## Quad Controls Prototype

Modifications to Quad Controls Prototype to fix the “d’s”

Advanced LIGO Suspensions

T050172-00-D

## Top stage and Blades

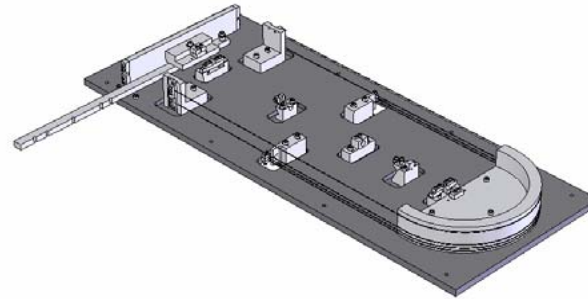
- » Default 106 mm from the “seismic table” to the top of the blade
  - Actual 108mm at thick end of blade!
  - 110 mm at blade tip!
    - SUGGESTION TO SHORTEN TOP WIRE BY 5mm!!

- clamps or blades? Blades!
  - Down by ~ 2mm!
    - » 007 & 006 with V6 instead of V8 (blade tip now lower)
    - » 001 & 004 with V2 instead of V0 (blade tip now lower)

- clamps or blades? Blades!
  - Down by ~ 2mm!
    - » 005, 012, 001 & 008 with V4 instead of V6! (blade tip now lower)

## Top Wire

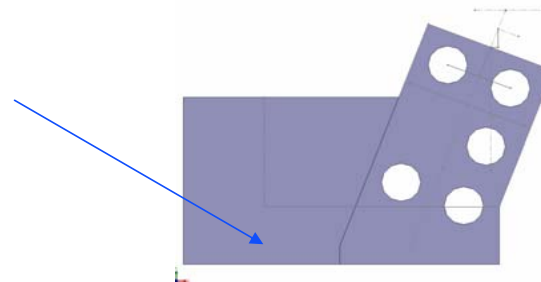
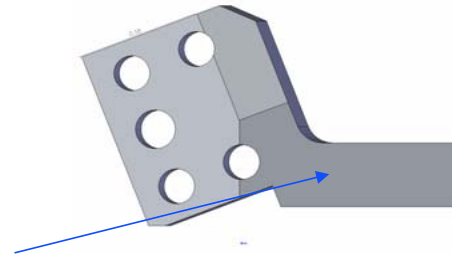
- Top blade to top mass
  - » F.P. from 5 mm to 2.5 mm
    - Removed 2.3 mm off top blade wire clamp, to keep FP at CG of blade
    - Added 2.3 mm to top wire clamp at top mass

## UI Wire

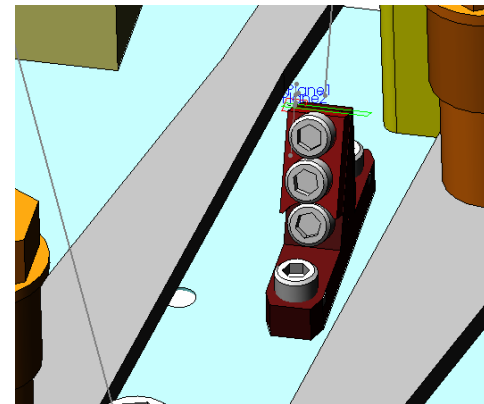
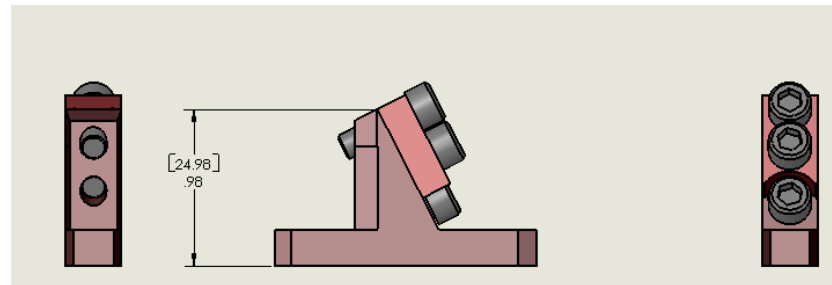
- Middle Blades to UI mass
  - » 'd' value still 1mm above CG but flexure point now only 1.7 mm instead of 3.35mm. Therefore, break off needs to move up 1.7mm or clamp needs to get 1.5 mm taller in vertical Z (after resolving)
  - » Also chose to make thinner clamp to ease interference with blades!
- Blades, ref slide 4

## Penultimate Wire

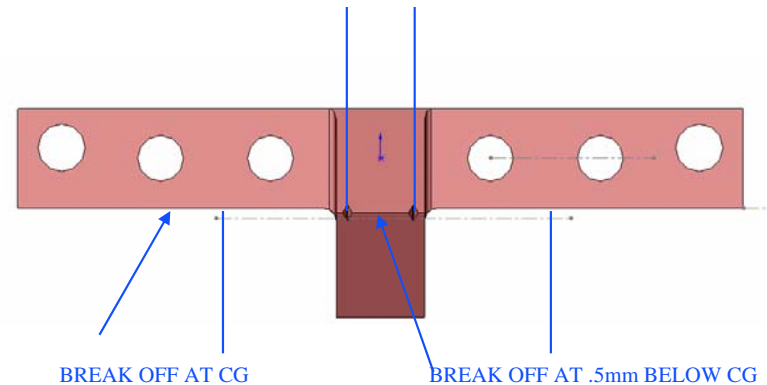
- Bottom blade to pen mass
  - NEW PEN WIRE CLAMP
    - Final wire break off at CG
    - Pen wire break off 0.5mm below CG so “d” value at FP 1mm above CG (FP now ~ 1.5 mm)
- Blades, ref slide 8

### MODIFIED REACTION MASS CLAMP

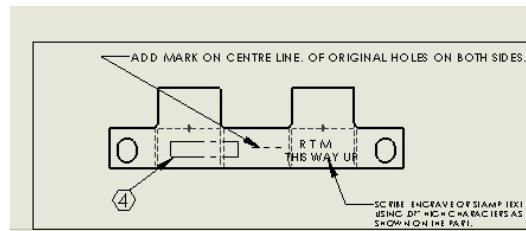
- Pen mass to test mass
  - » FP reduced from 2 mm to 1 mm.
  - » “d” vaule still 1mm above CG.
  - » Therefore clamp re-designed to have slots so as break off can be positioned at CG!
